STAGE 1 ROAD SAFETY AUDIT
BINLEY CYCLEWAY – BRINKLOW ROAD TO B4082

2. **ITEMS RESULTING FROM THIS STAGE 1 ROAD SAFETY AUDIT**
BINLEY CYCLEWAY – BRINKLOW ROAD TO B4082

2.1 **Problem:** Pinch-point on cycleway

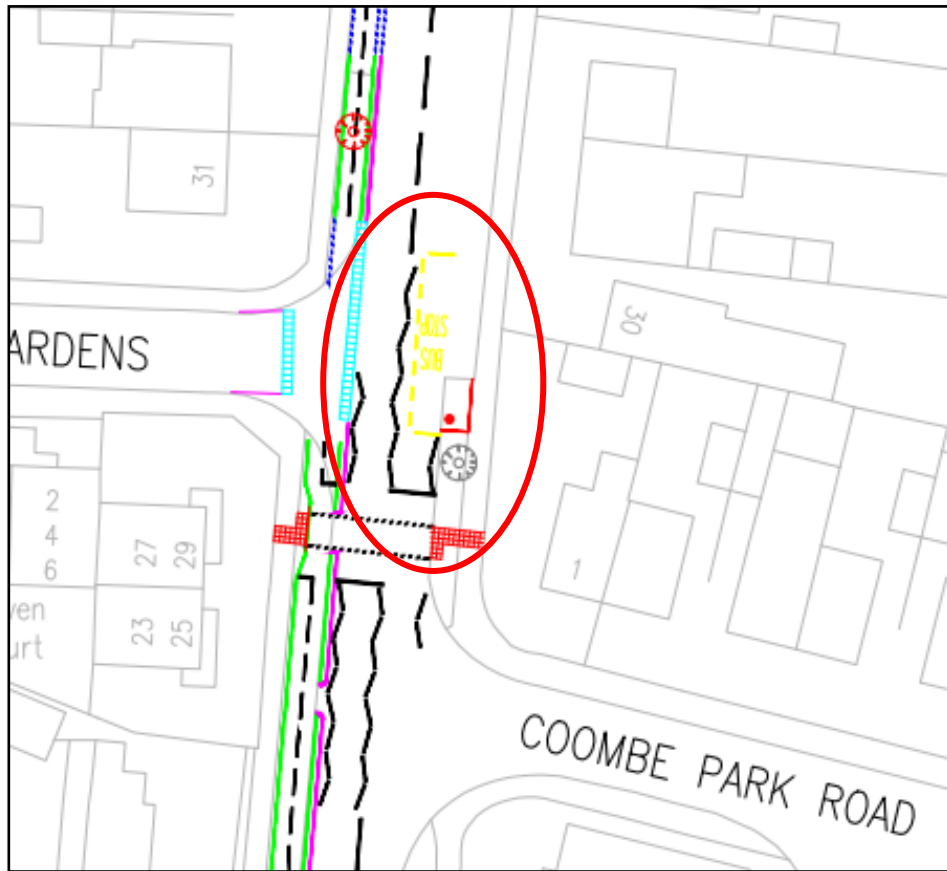
There is a significant narrowing on the cycleway, and this presents a significant road safety hazard. The dynamic kinetic envelope of the cyclist must be included into the design and the design should optimise a cyclist in motion moving laterally to maintain balance. Pinch-points and horizontal alignments on a two-way cycleway may result in cyclist head-on type personal injury collisions. In addition, cyclists may opt to use the footway to traverse this pinch-point and this significantly increases the likelihood of cyclist to pedestrian type personal injury collisions.

Redesign this section of cycleway to remove the pinch-point/ horizontal alignment. This will reduce the likelihood of cyclist head-on and cyclist to pedestrian type personal injury collisions.

2.3 Problem: Existing Post-Box on scheme route

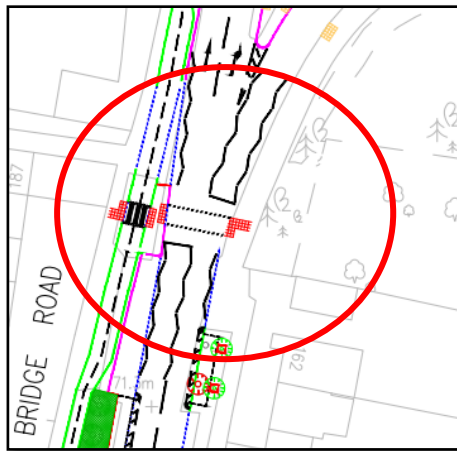
There is an existing Post Box that will create a significant narrowing of the footway, and this presents a safety hazard. A pedestrian, particularly if using a mobility scooter, may have to enter the cycleway to traverse this location, which would involve negotiating the 45' kerb and travelling along the cycle track, which is at a lower height. This may result in conflicts with cyclists or a mobility scooter or wheelchair tipping over. This significantly increases the likelihood of cyclist to pedestrian type personal injury collisions.

Redesign this section of the footway and cycleway to either relocate or remove the Post Box thereby removing the obstacle. This will reduce the likelihood of cyclist to pedestrian type personal injury collisions.

2.4 Problem: 40mph Speed Limit on Approach to Controlled Pedestrian Crossing

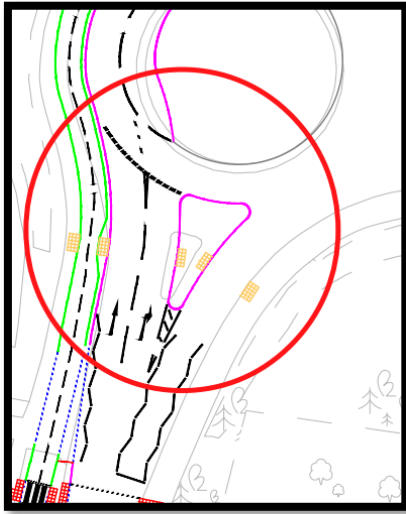
The controlled pedestrian crossing is being proposed in close proximity to the 40mph speed limit. Inappropriate speeds on the approach to a formalised pedestrian crossing significantly increases the likelihood of vehicle to pedestrian type personal injury collisions.

Reduce the speed limit on the approach to the pedestrian crossing facility. In addition, ensure there is high friction surfacing on the approaches to the formal crossing facility. The reduction in the speed limit and the installation of the high friction surfacing will reduce the likelihood of vehicle to pedestrian type personal injury collisions.

2.6 Problem: Cycle Prevention Gate

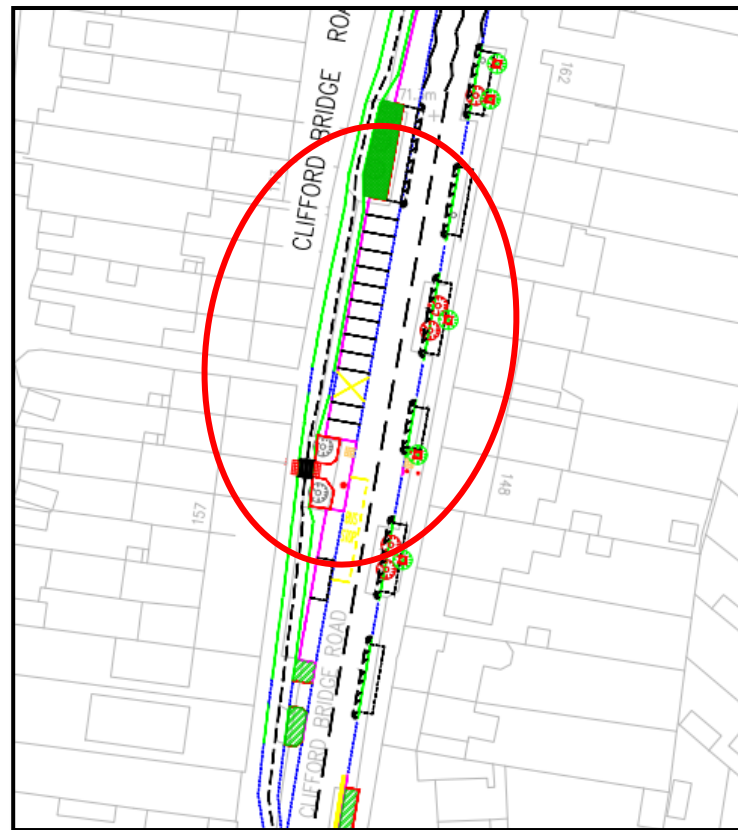
There is an existing cycle prevention gate in between properties 98 and 100 Clifford Bridge Road, the drawing shows a proposed 45' kerb down the middle of this route, it is assumed this becomes a segregated pedestrian and cycle path. The cycle prevention gates are in-line with the proposed cycle track route from Clifford Bridge Road. At the eastern end of the path (between 147 & 149 Coombe Park Road) there appears insufficient width to provide this facility, this significantly increases the likelihood of pedestrian (and other vulnerable footway user) to cyclist personal injury collisions.

Remove the cycleway gate and provide adequate "shared-use" facilities at this location. This will reduce the likelihood of cyclist to vulnerable footway user personal injury.
